Office Action Summary

10/027,238

SHERWIN, JOHN P.

DETAILED ACTION

Exhibit A**Conclusion**

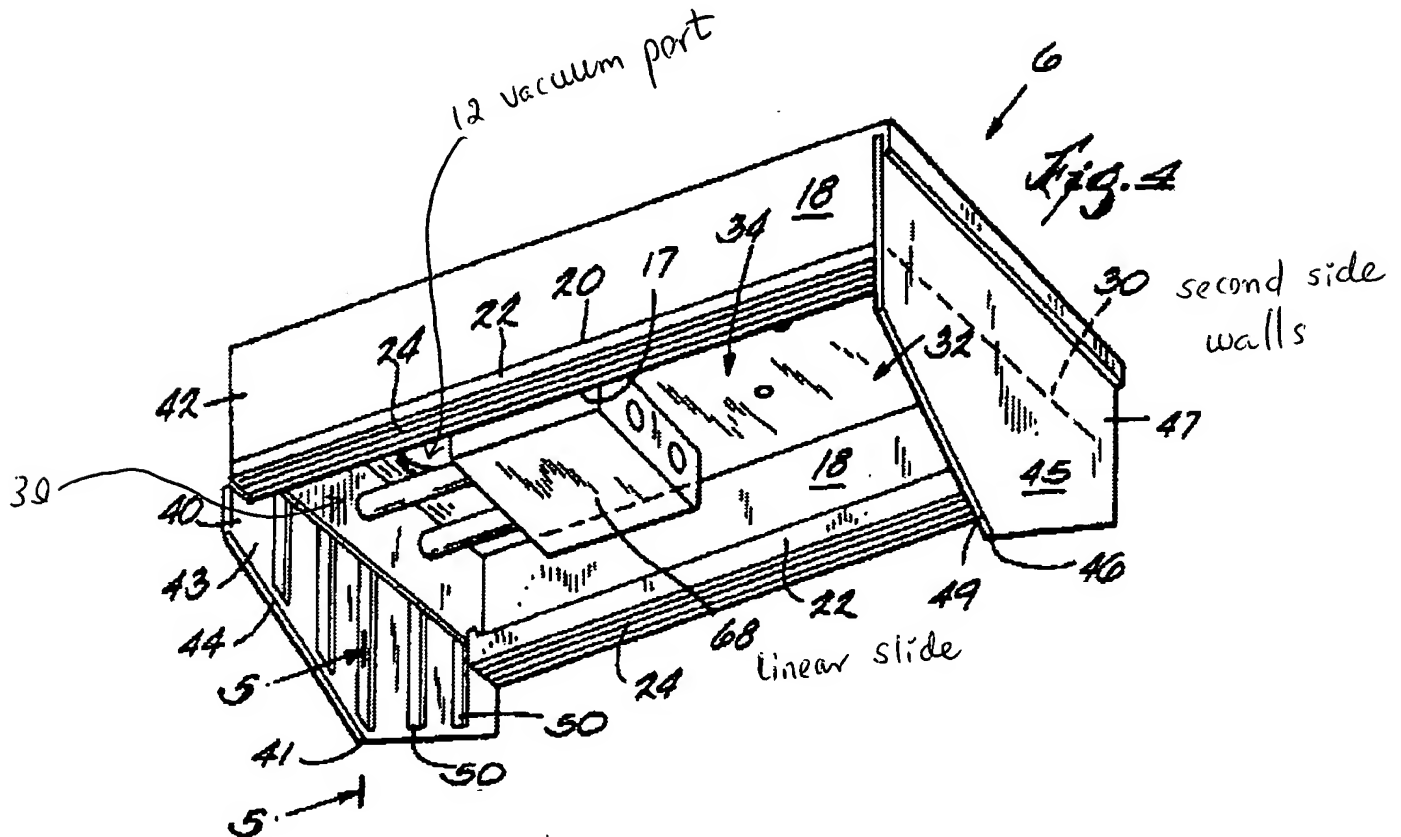
Moreover, applicant argues that the newly presented limitation of claim 1 ("first and second gripping elements are arranged separately and independently from the vacuum port") is patentably distinguishes from the prior art. The argument is not persuasive because the prior art meets the limitation. Holter's gripper (5,727,832) shows that the first and second gripping elements (40,45) being arranged separately and independently from the vacuum port (12) (see Fig. 4). It is pointed out that the gripping element (40) is being movably coupled a linear slide (68) and being operated separately and independently from the vacuum port (12) wherein the

gripping element is independently and separately movably mounted and the vacuum port (12) is permanently fixed in the plate (10) (see Exhibit A below).
